ADDENDUM

ADDENDUM NO. 3

DATE: July 21, 2020

BRENDA M. MOORE  
MUSKEGON COUNTY DRAIN COMMISSIONER  
STEPHANIE BARRETT, DEPUTY DRAIN COMMISSIONER  
BLACK CREEK CONSOLIDATED DRAIN DRAINAGE DISTRICT  
DIVISION 1  
JTB&S DRAIN AT M-46

APPLE AVE (M-46)  
ROADWAY CROSSING DETAIL

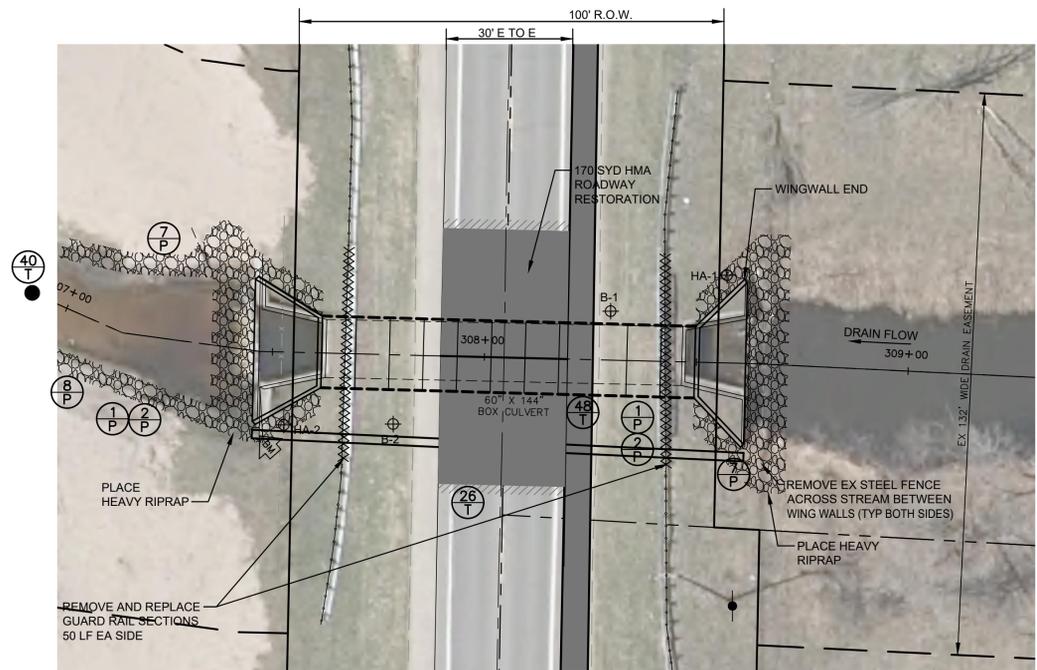
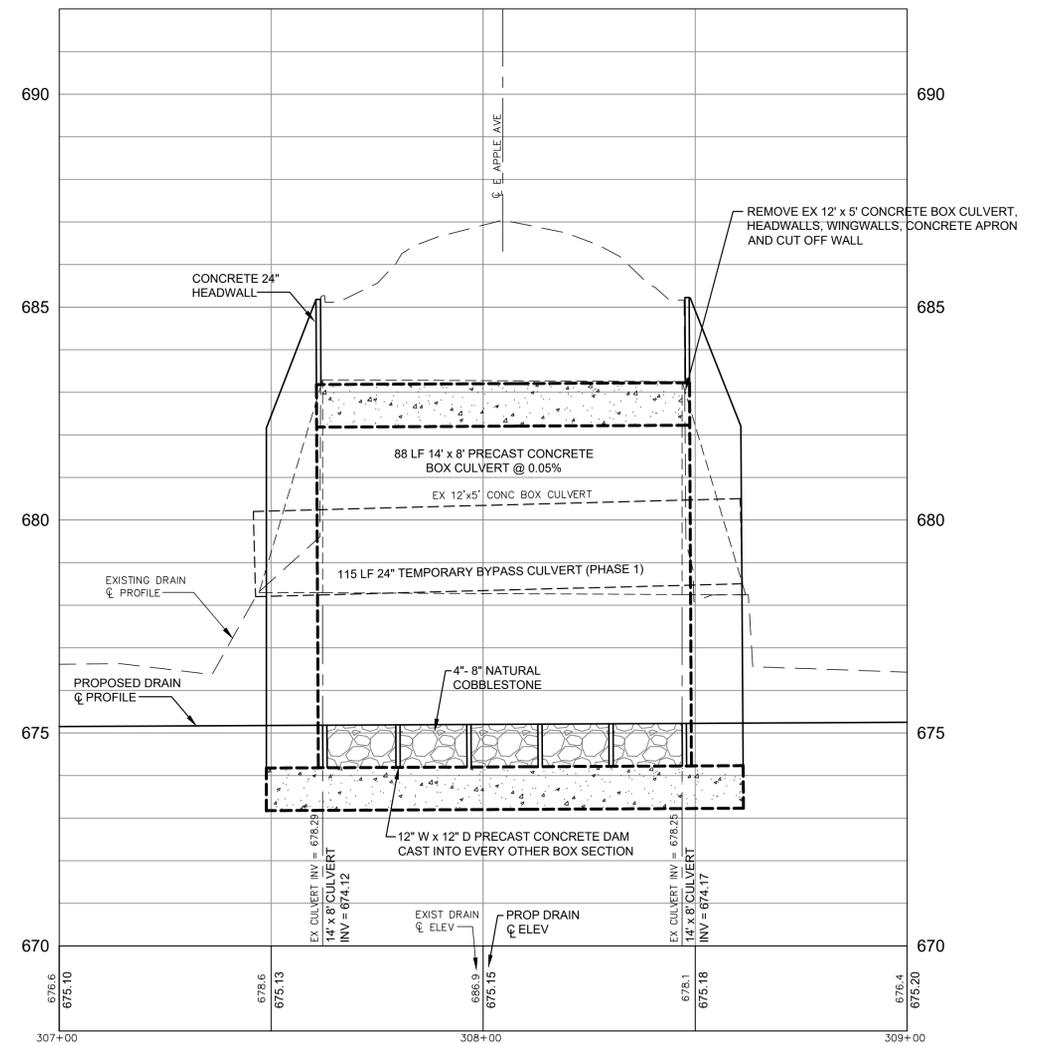
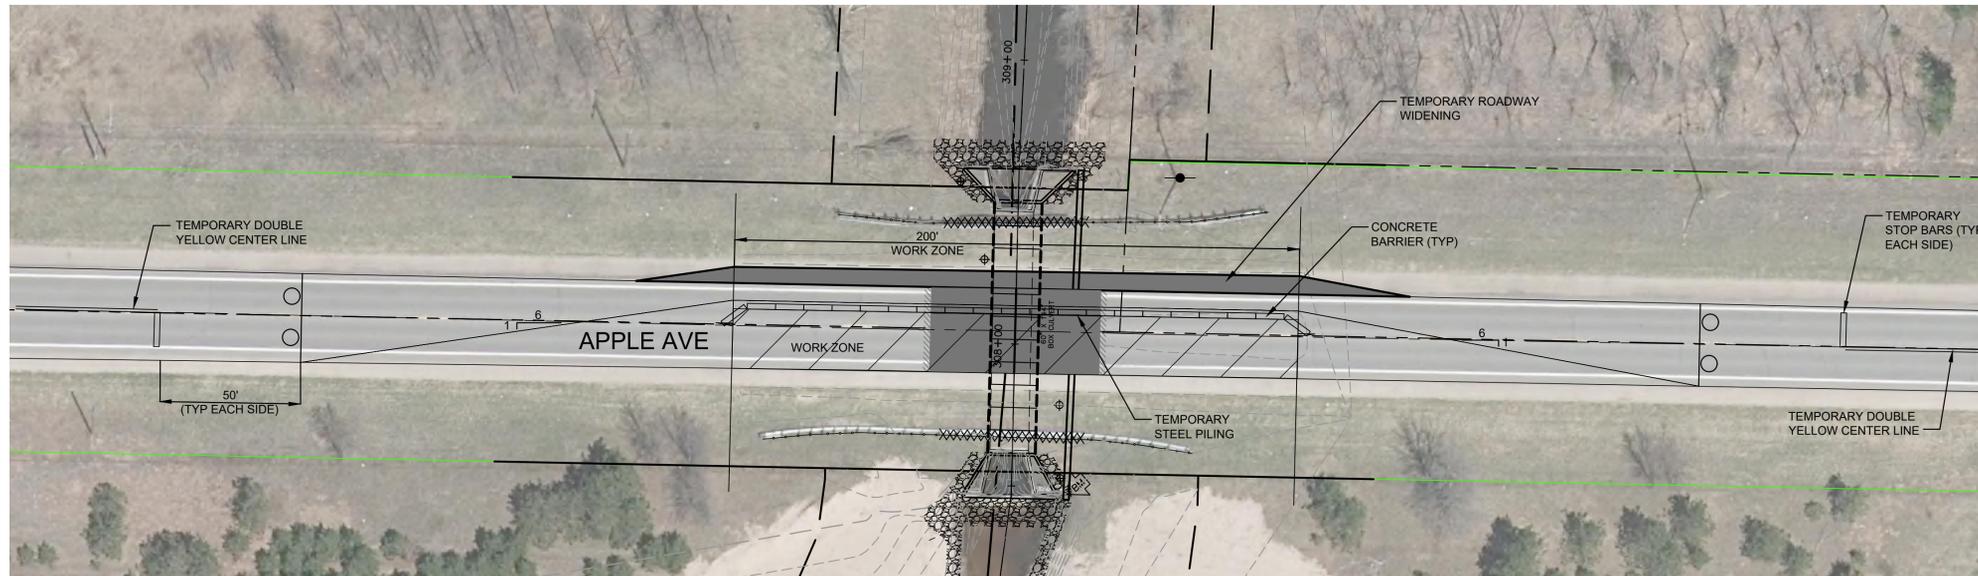
Drawing Sheets Issued Herewith: Sheet 2 revised and re-issued, Sheet 4a added to the set

Quantities for Items No. 4, 15, and 16 have been revised. Item No. 41 Traffic Control, Part Width Construction has been deleted. Additional Items No. 41-53 have been added to the Bid section. See Addendum No. 3 Bid section included in this addendum; Bidder must use this Addendum No. 3 Bid section to submit Bid.

NO.	REVISIONS	DATE	BY	DATE	BY
1	ADDENDUM NO. 3	7/21	JAJ	7/21	SPM

PHASING PLAN

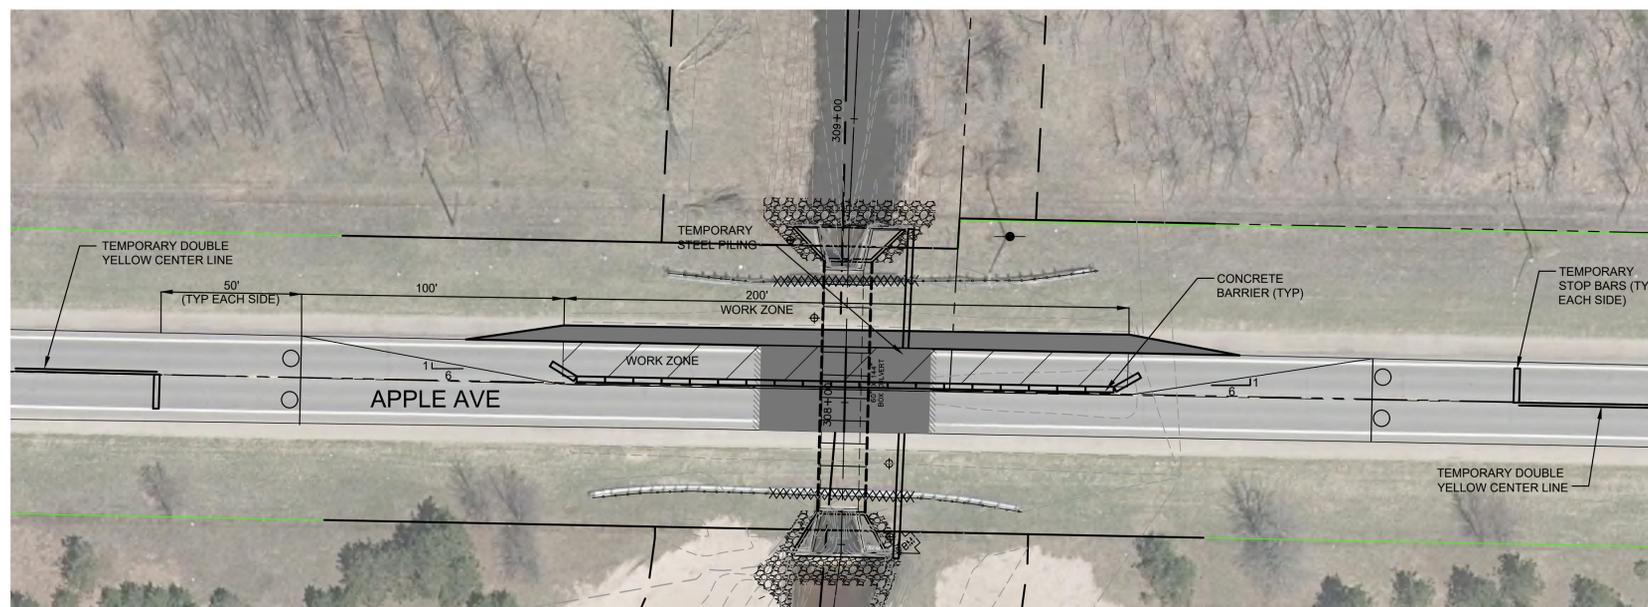
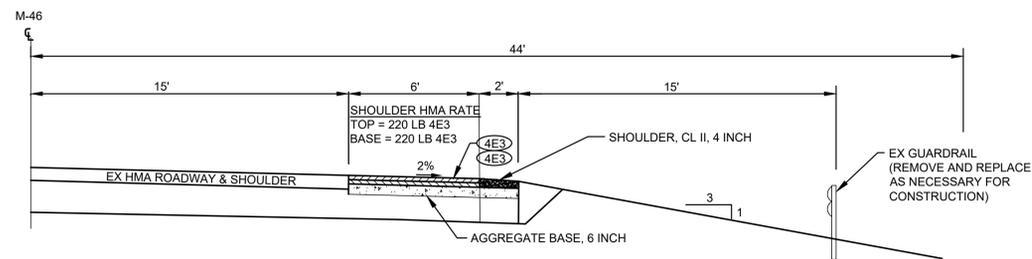
- 2. Unit of measure: Each.
  - E. Item No. 10 – Maintain Stream Flow.
    - 1. Includes: Submitting a plan for approval and maintaining stream flow during the preparation and placement of the proposed precast concrete box culvert in accordance with Section 401 of the MDOT 2012 Standard Specifications for Construction **utilizing the 24 inch directionally drilled temporary storm sewer shown on the revised drawings.**
